## INSTRUCTION BULLETIN

No. 340216  
Machine: 8200, 8210  
Published: 11-98/00  
System: OPTIONS

Installation instructions for kit number 365366

This kit contains the parts needed to replace the engine cover latch on the model 8200 sweeper/scrubbers with ID numbers lower than 6055 and 8210 sweeper scrubbers with ID numbers lower than 1061.

**FIG. 1 - Engine Cover Latch Removal**

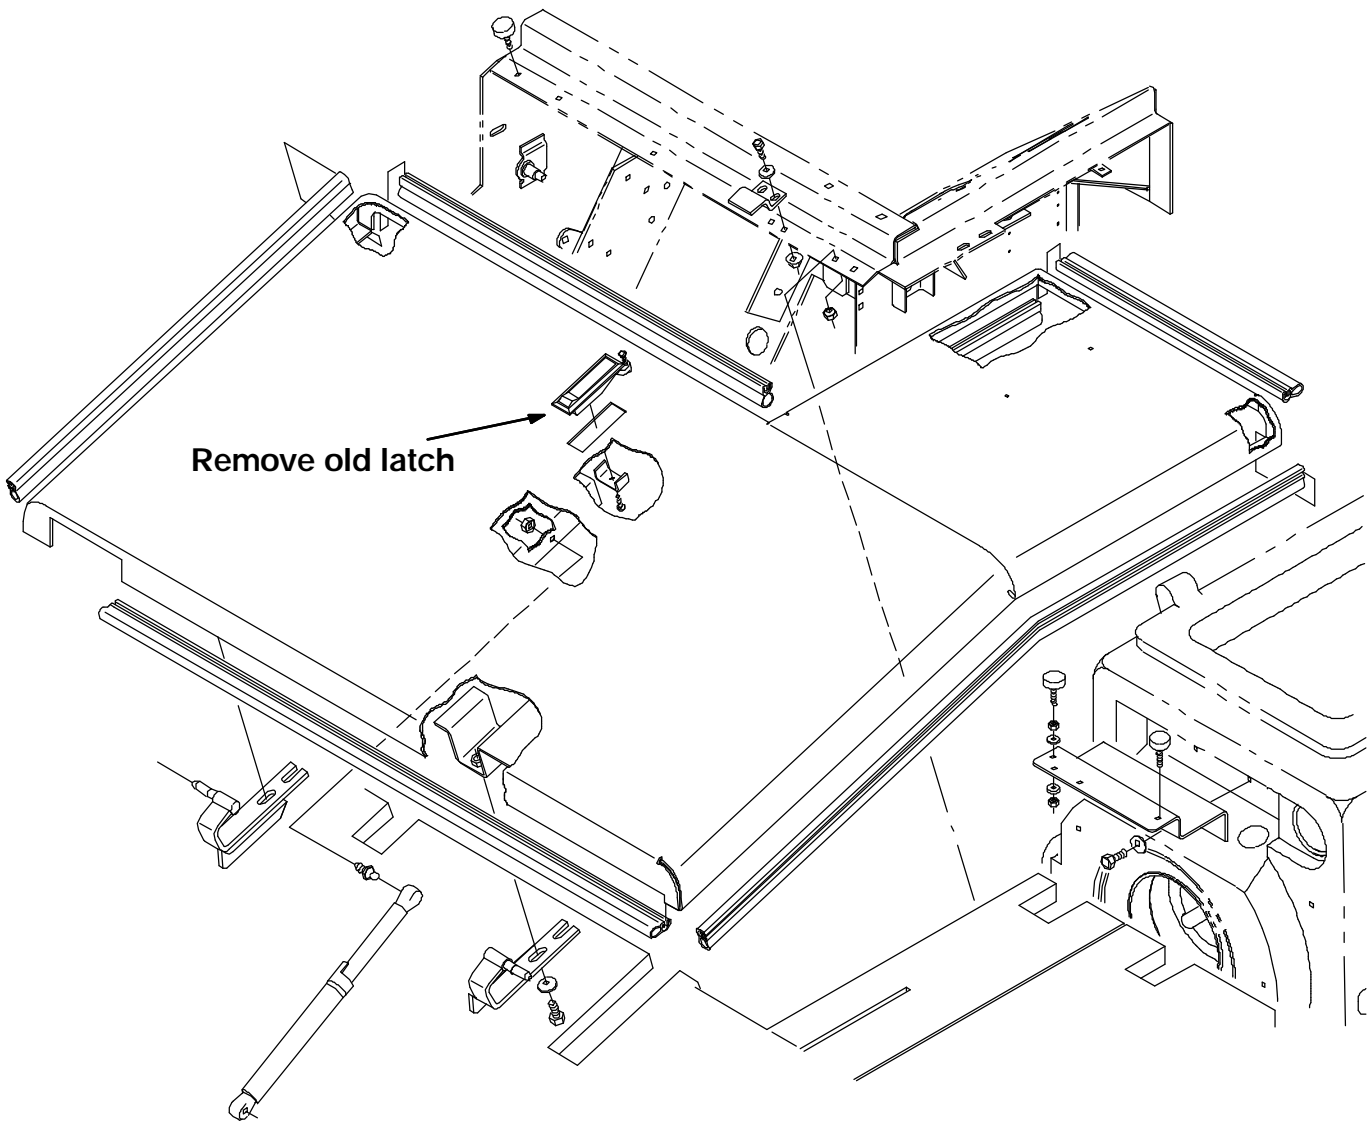
1. Open engine cover.
2. Remove old engine cover latch.
3. Remove .320 inch of material from the top of the engine latch opening with a file or small hand detail grinder.
4. Sand the opened area smooth.
5. Install new engine cover latch (1).
